Architectural Review
and Historic Preservation Board
Agenda Report

File : AR 15-33

RE: Reed Apartments, Phase II
1131 W. 5th Street and 505 Oak Street, AP Nos. 004-201-002 and 004-201-001

SITE PLAN

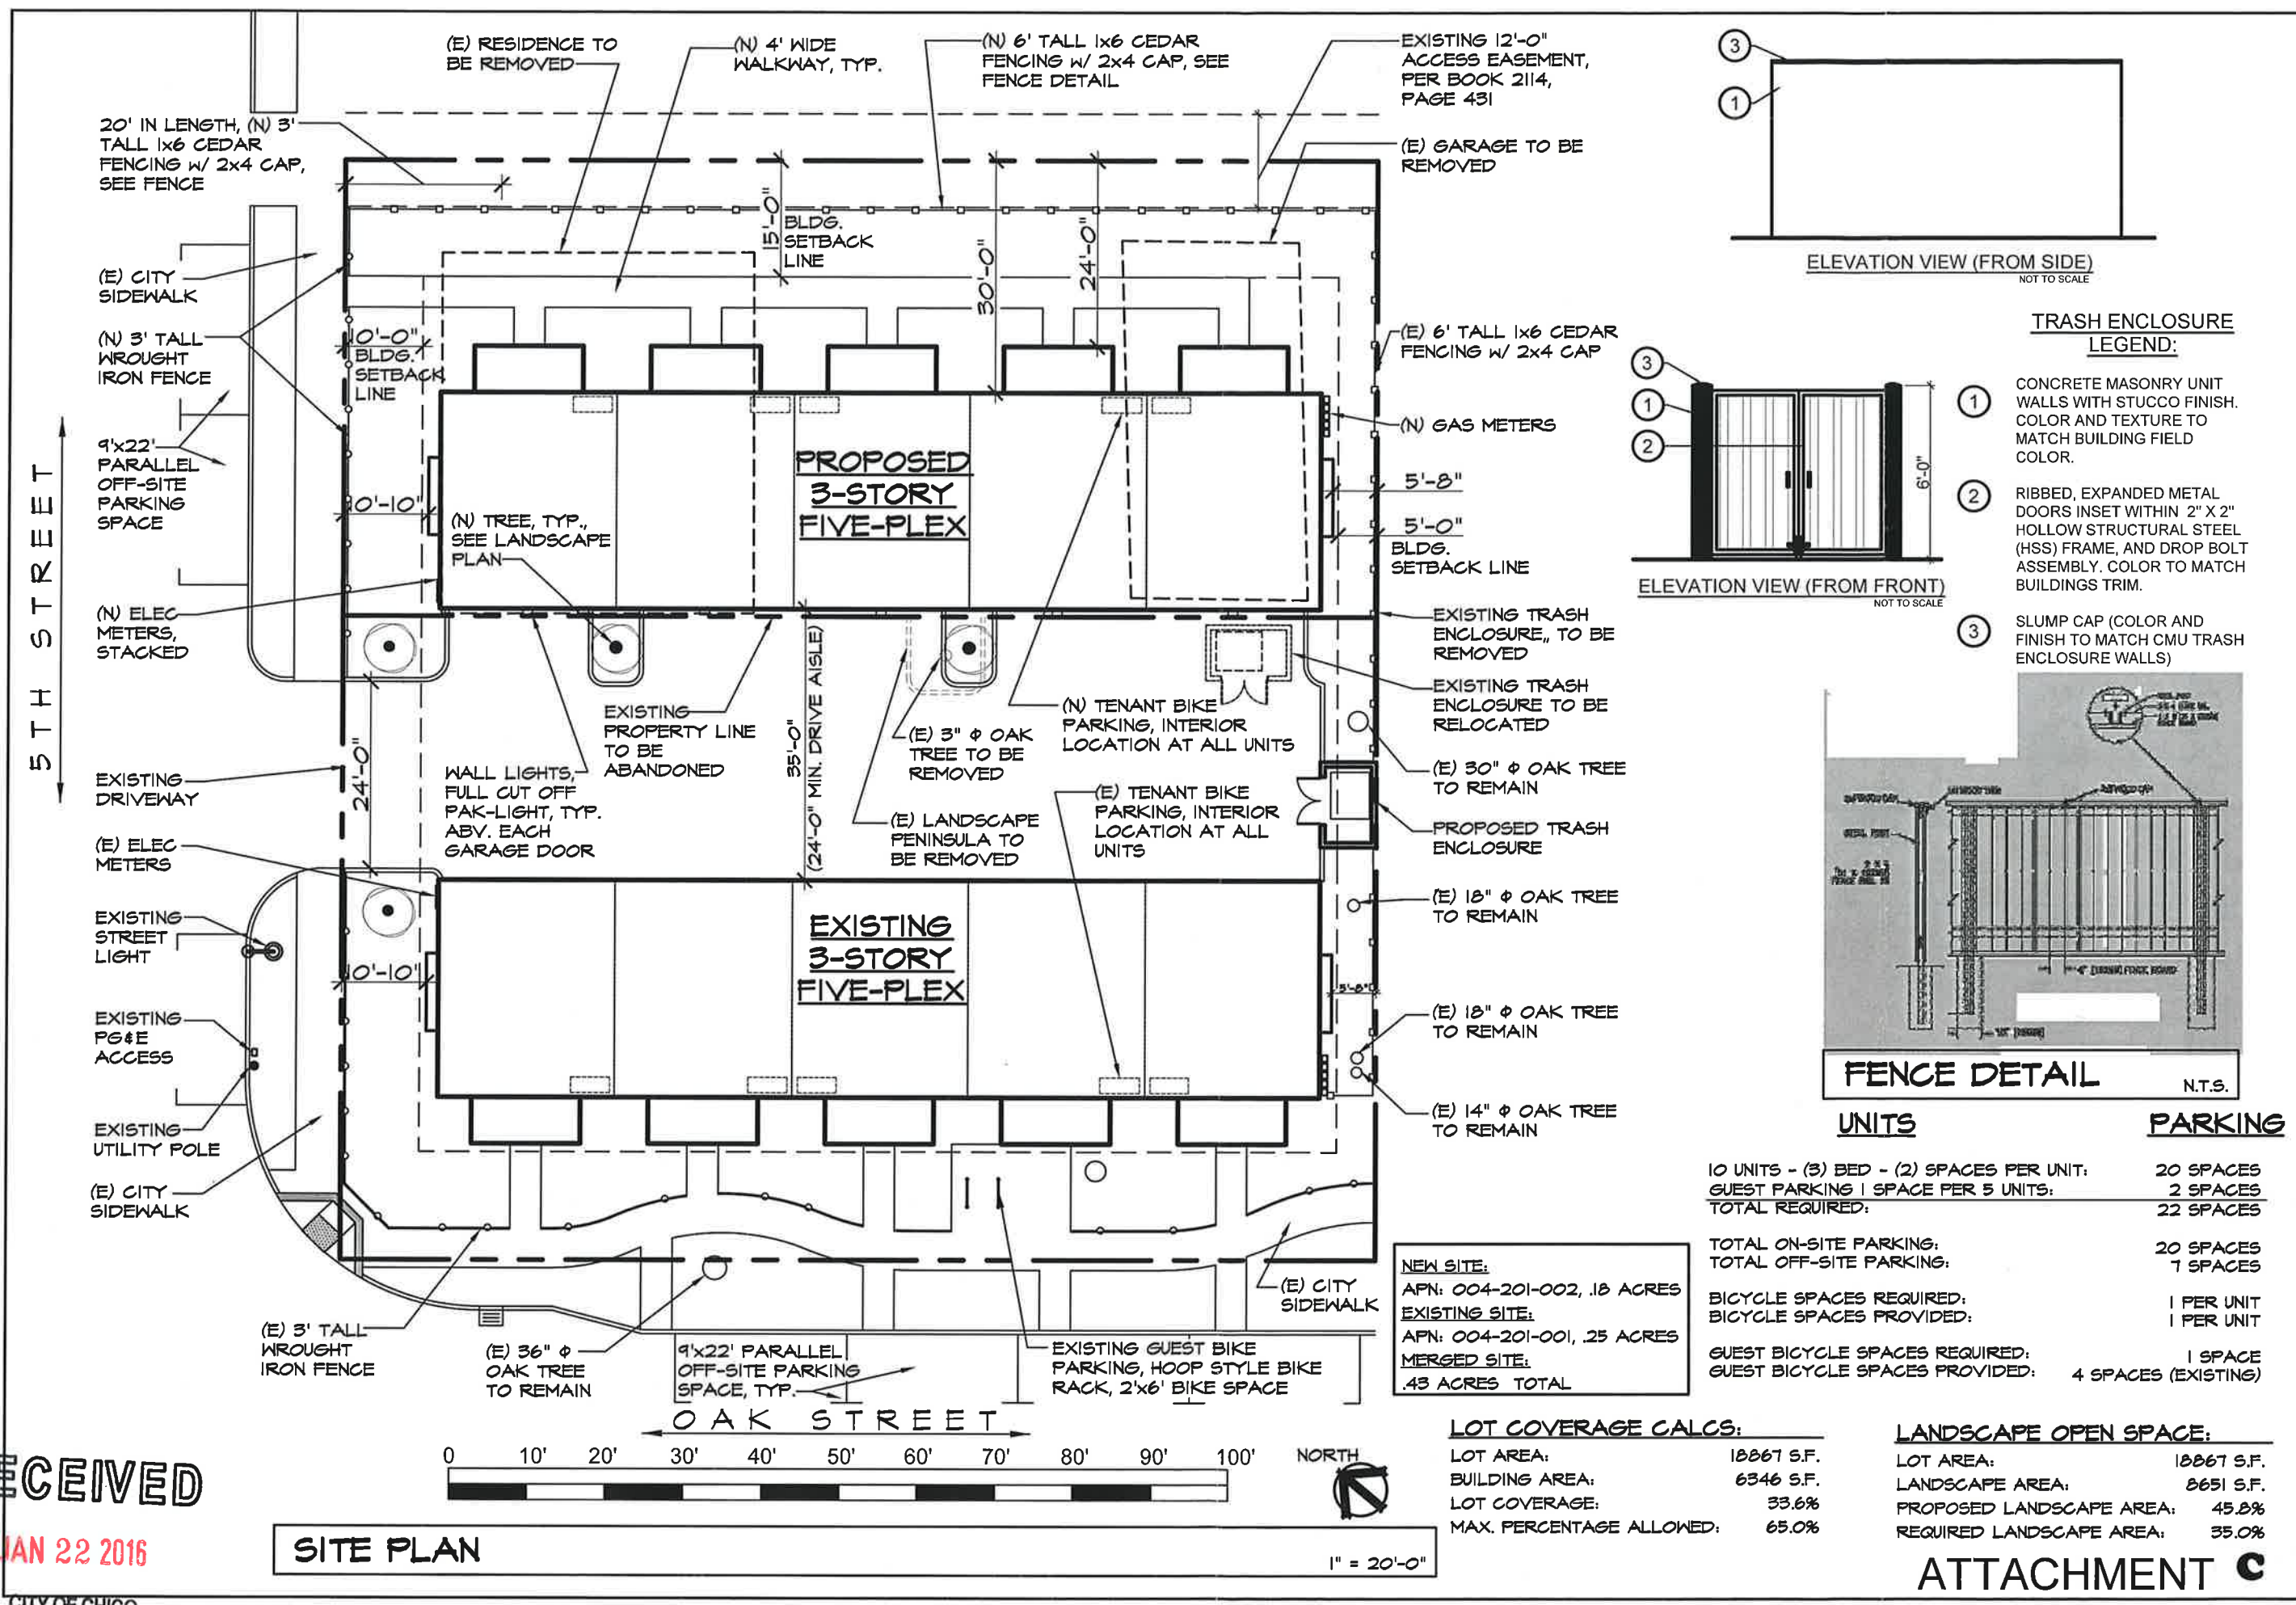
The site plan labels both existing and proposed fencing as "6' tall 1x6 cedar fencing with 2x4 cap" and includes a detail depicting the same. Since the existing fence does not have a 2x4 cap a condition is recommended to add the 2x4 cap for a consistent appearance.

Driveway Width: Provided that DGs 4.1.32 and 4.1.51 encourages shared driveways to reduce the amount of impervious surfaces associated with development projects, discuss if the drive aisle shall be reduced in width to avoid excessive amounts of paved area and increase the amount of landscape area along the eastern boundary of the site. For reference, CMC 19.70 only requires a 24-foot wide drive aisle to accommodate vehicle circulation and the proposed drive aisle widens to 35 feet between the buildings. Reducing the amount of paved area would also enable smaller-canopy shade trees to be planted in the parking area, reducing potential

conflicts between tree growth and the new building. Staff recommends hearing any supporting rationale for the proposed driveway width from the applicant and weighing that against the standards, DGs, and site planning issues cited above.

5. All building and landscape plans shall note the addition of a 2x4 cap on existing fencing so that all perimeter 6-foot fencing is consistent with the detail shown on the approved site plan.

PRELIMINARY LANDSCAPE PLAN

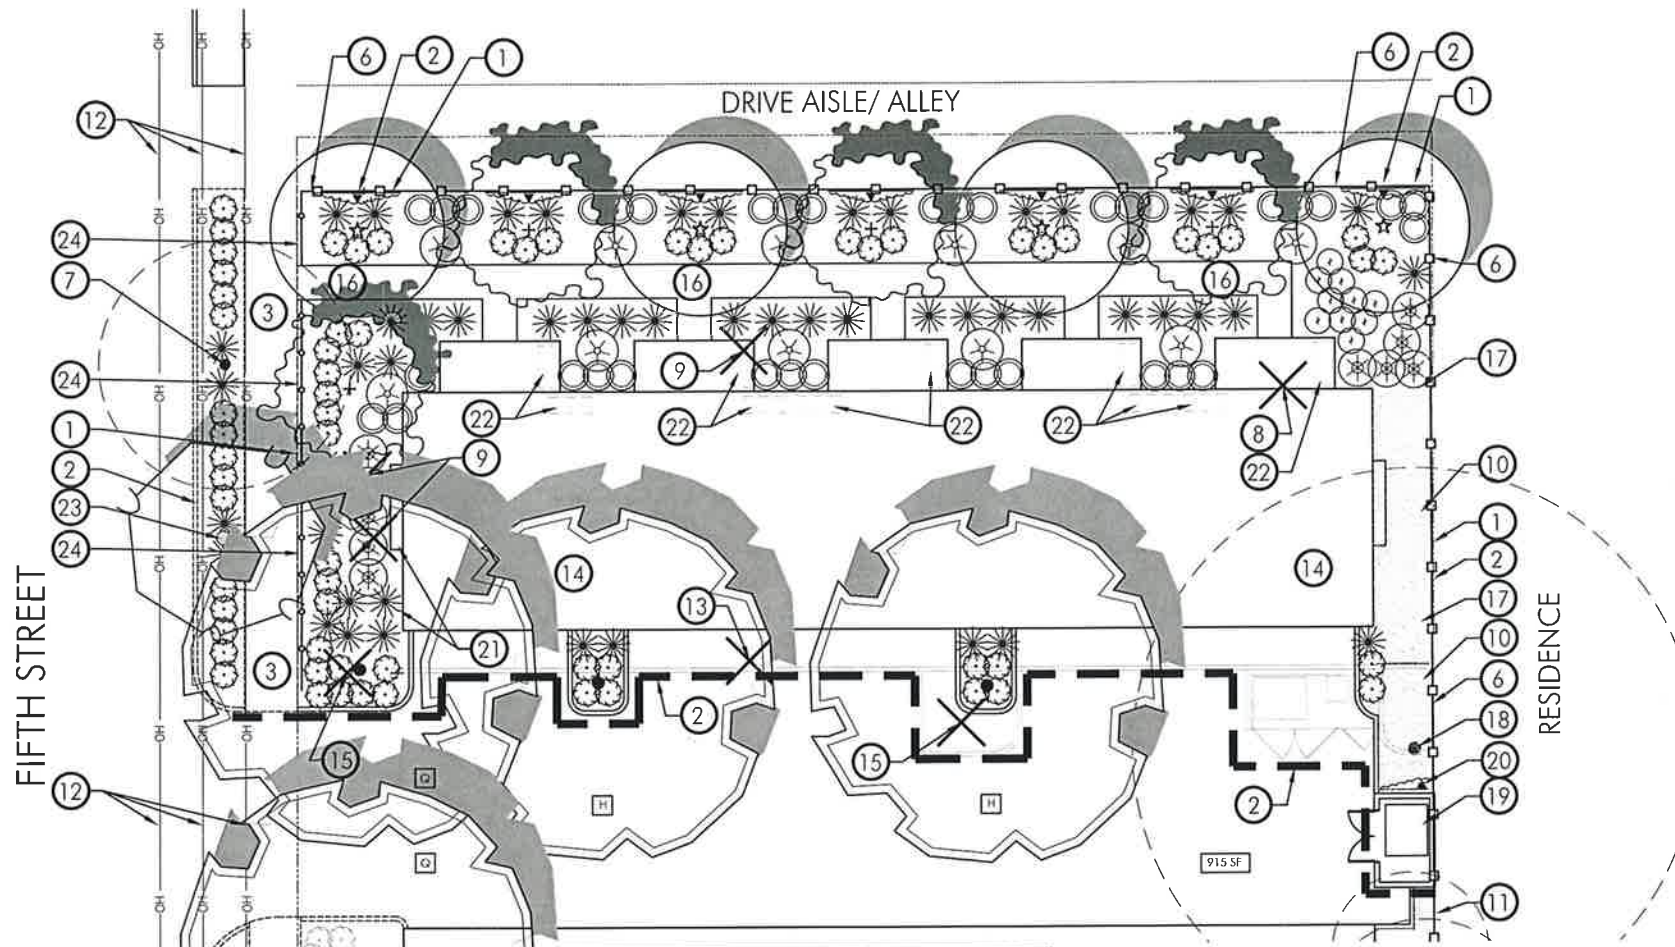
The proposed design would retain a large, healthy oak tree near the location of the proposed new trash enclosure. To ensure proper protection of the tree during construction, a condition is recommended that would require a Tree Protection Plan in compliance with CMC 19.68.060. The plan would be submitted in conjunction with building/grading permit plans, and would cover all phases of the project, including site preparation, construction, and post-construction.

4. In conjunction with building permit or grading permit review, the developer shall submit a Tree Protection Plan meeting the requirements of CMC 19.68.060. The Plan shall be prepared by a certified arborist and specify the actions necessary to minimize potential construction impacts on the trees that are to be retained, as specified by the approved plans. The Plan shall cover all phases of the project including site preparation, active construction, and post-construction disposition of the areas around the trees.

WALL LIGHTS, FULL CUT OFF PAK-LIGHT, TYP. ABV. EACH GARAGE DOOR

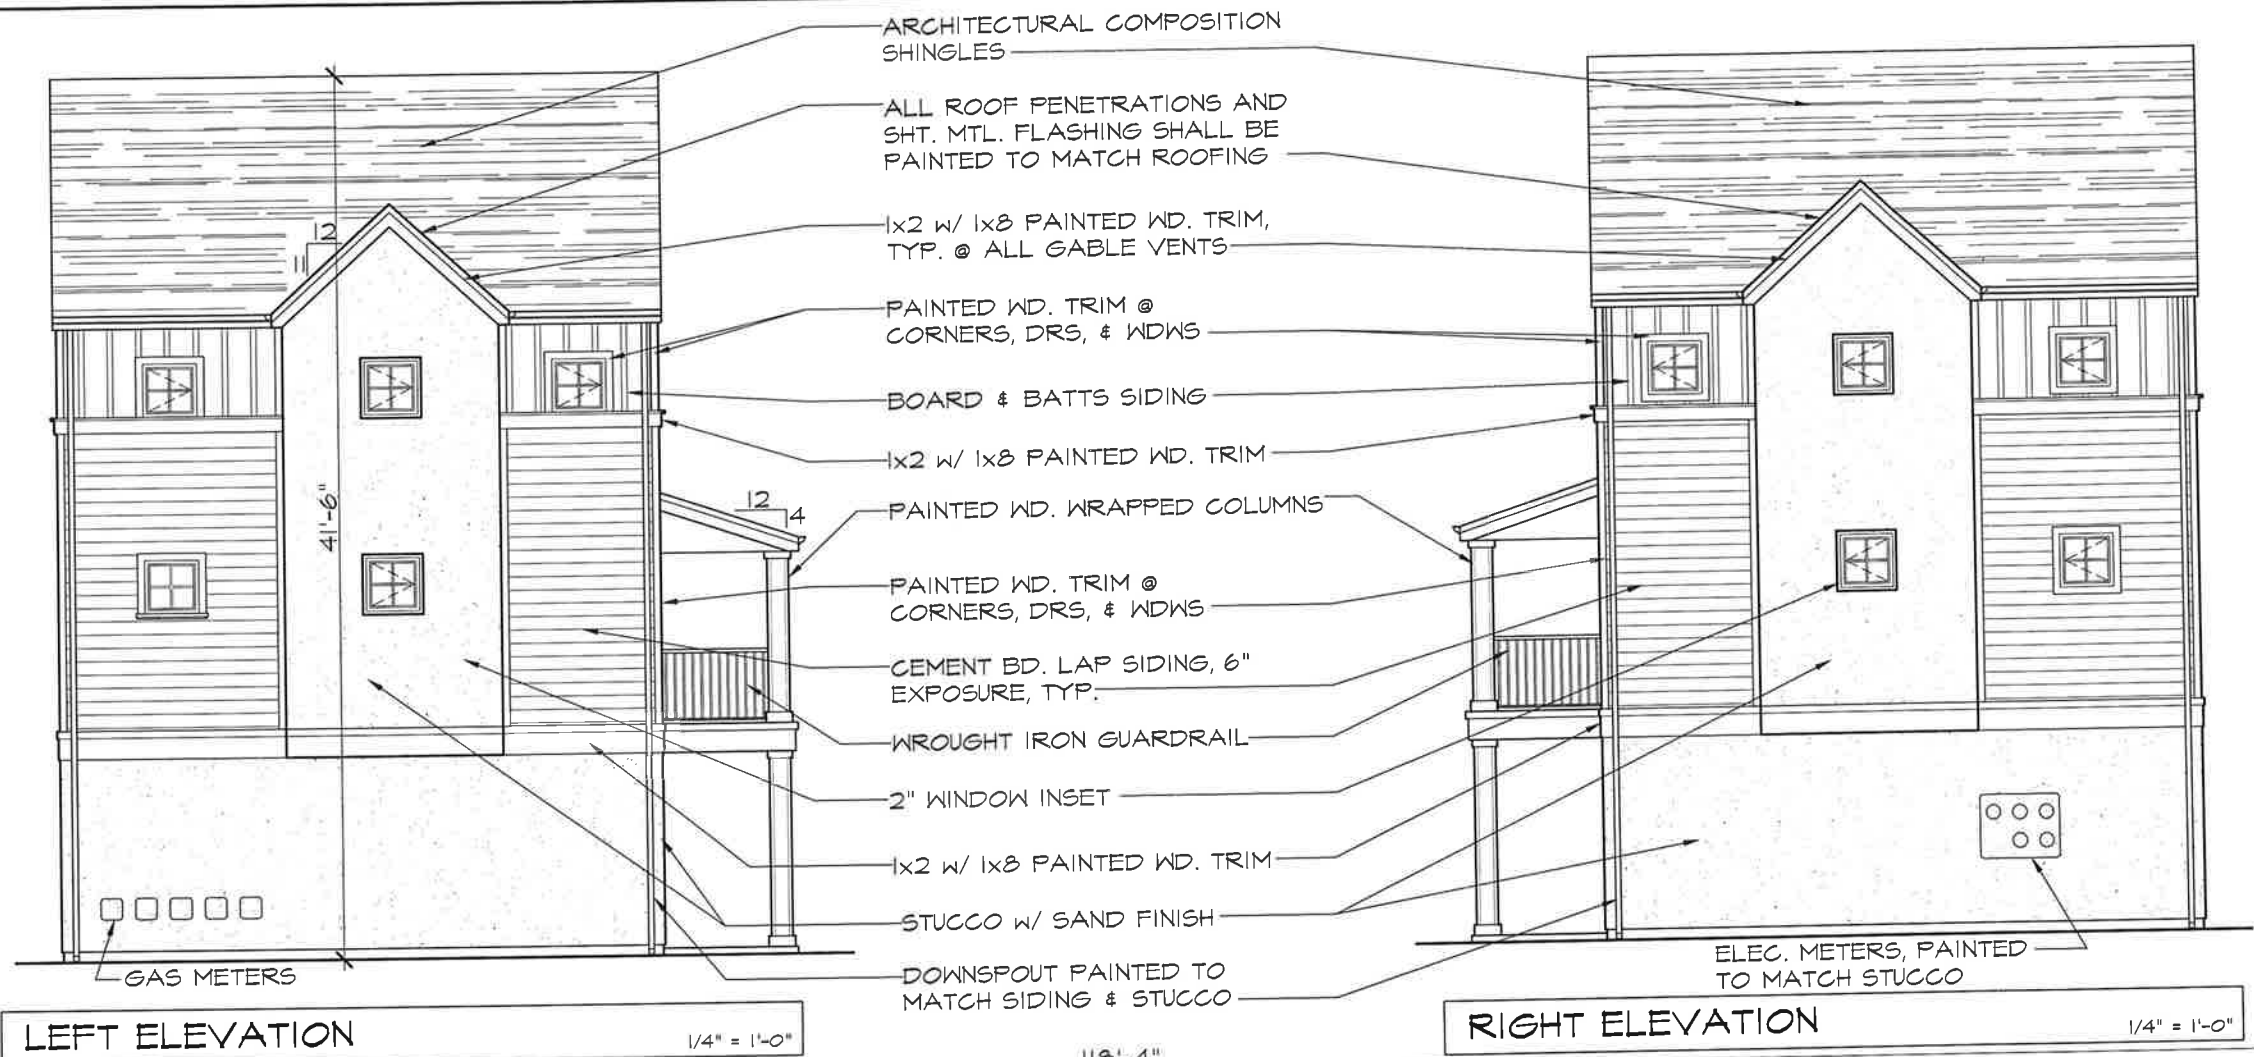
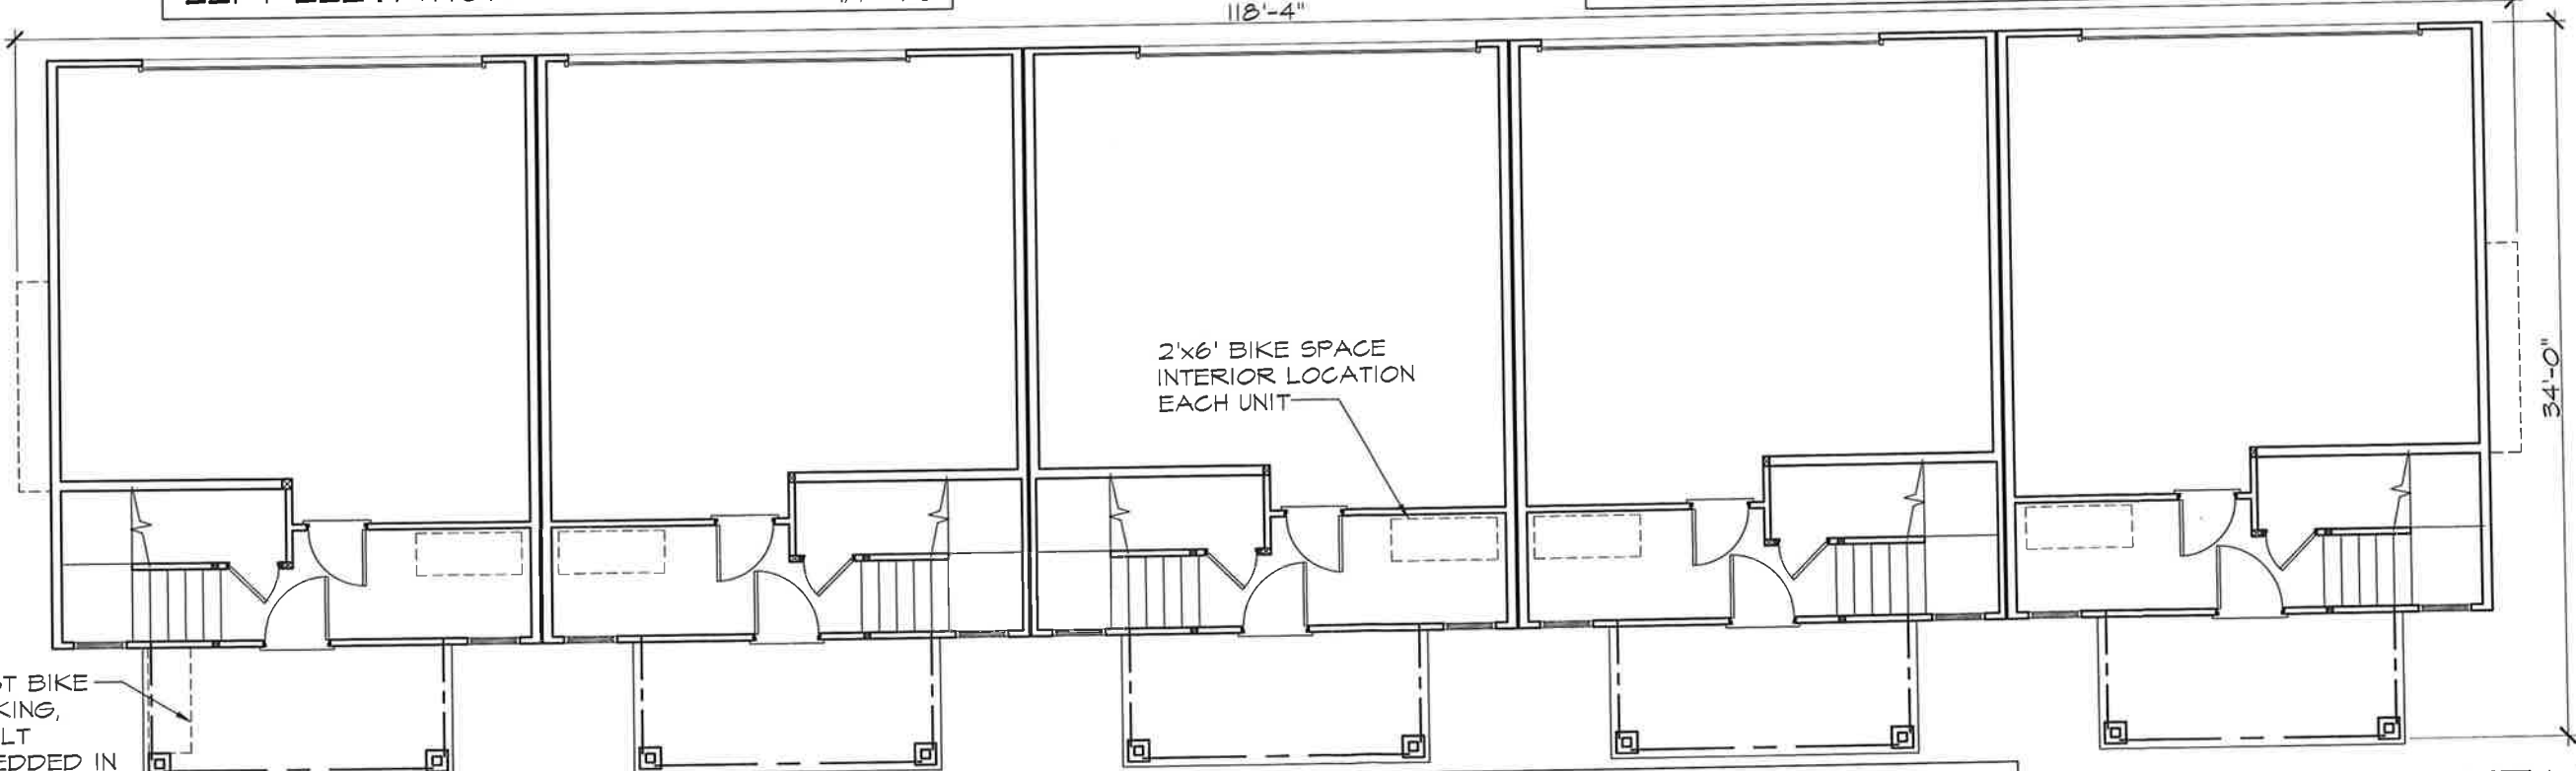
Modern wall pack lights are proposed over each garage door (see **Attachment I**, Lighting), and recessed can-lights are proposed in the ceilings of balconies and porches. A condition would require the new wall packs to match or be substantially consistent with the existing wall packs on Phase I.

3. The new wall pack light fixtures shall match or be substantially consistent with the existing wall packs on the Phase I building located at 505 Oak Street.
